APPROVAL FOR CONSTRUCTION

APPROVAL # 120424

PLAN OF PROPOSED
SEPTIC SYSTEM

PLAN OF PROPOSED REVISED SEPTIC SYSTEM

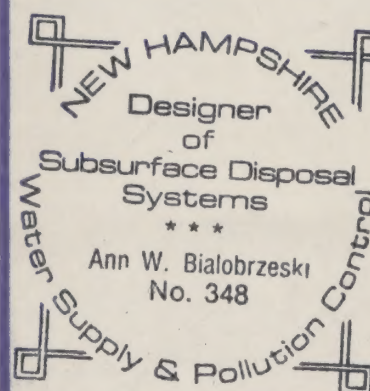
NOTE: (XX) Gravity system () Gravity system to septic tank and effluent pump chamber
with disposal system to be constructed on a properly prepared base.

(XX) no lower than the original grade

to maintain (XX) 4 ' minimum above (the reported) (any) seasonal high water table.

(XX) Fill to prepare disposal area should be a medium to coarse sand (0.5 to 1.0 mm).
